Gateway Trucking Transportation Memorandum (LSC #S214360) May 20, 2021

LSC Responses to EPC PCD TIS Redline Comments

Transportation Memorandum

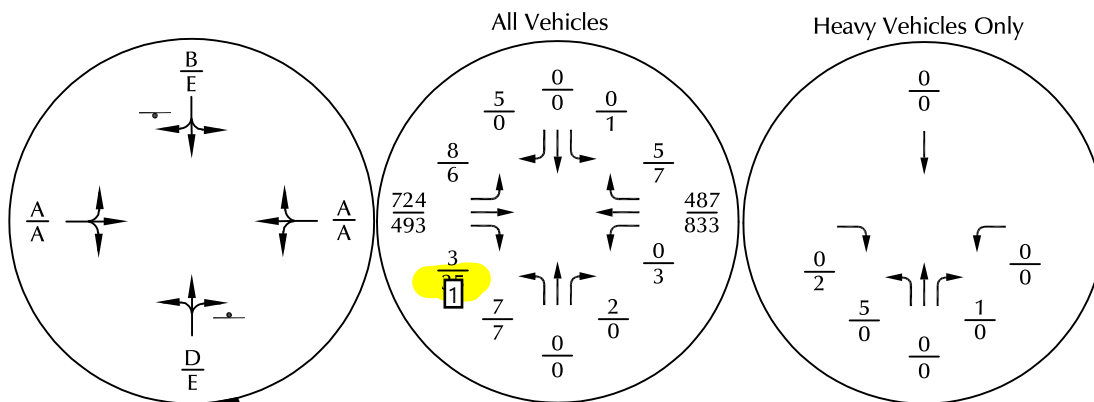
[Fix reference.](#)

LSC Response:
Fixed as requested.

Figure 3 Existing Traffic, Lane Geometry, Traffic Control, and LOS

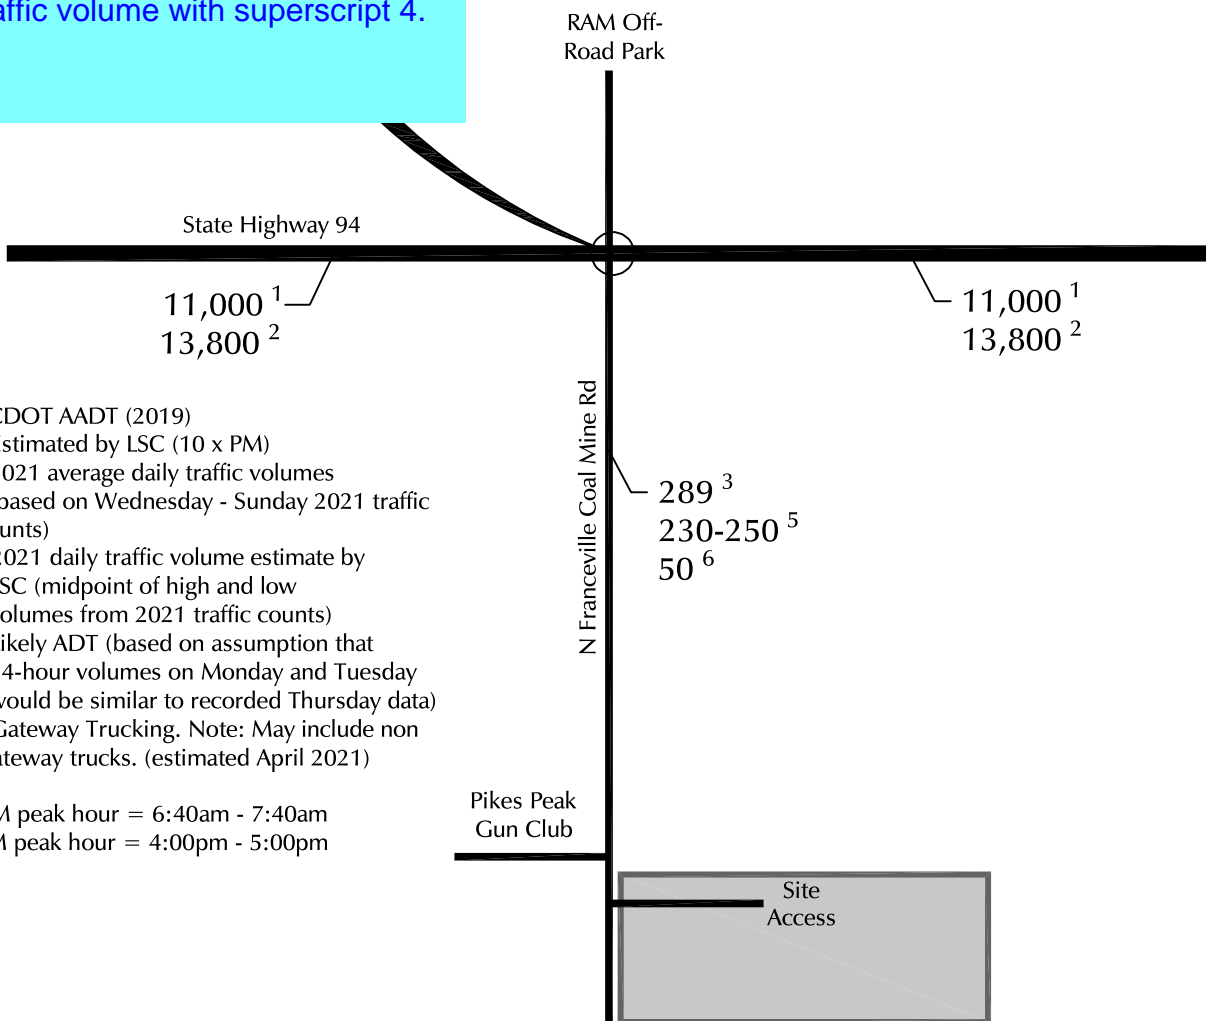
[Update the exhibit to include the traffic volume with superscript 4.](#)

LSC Response:
Updated as requested.
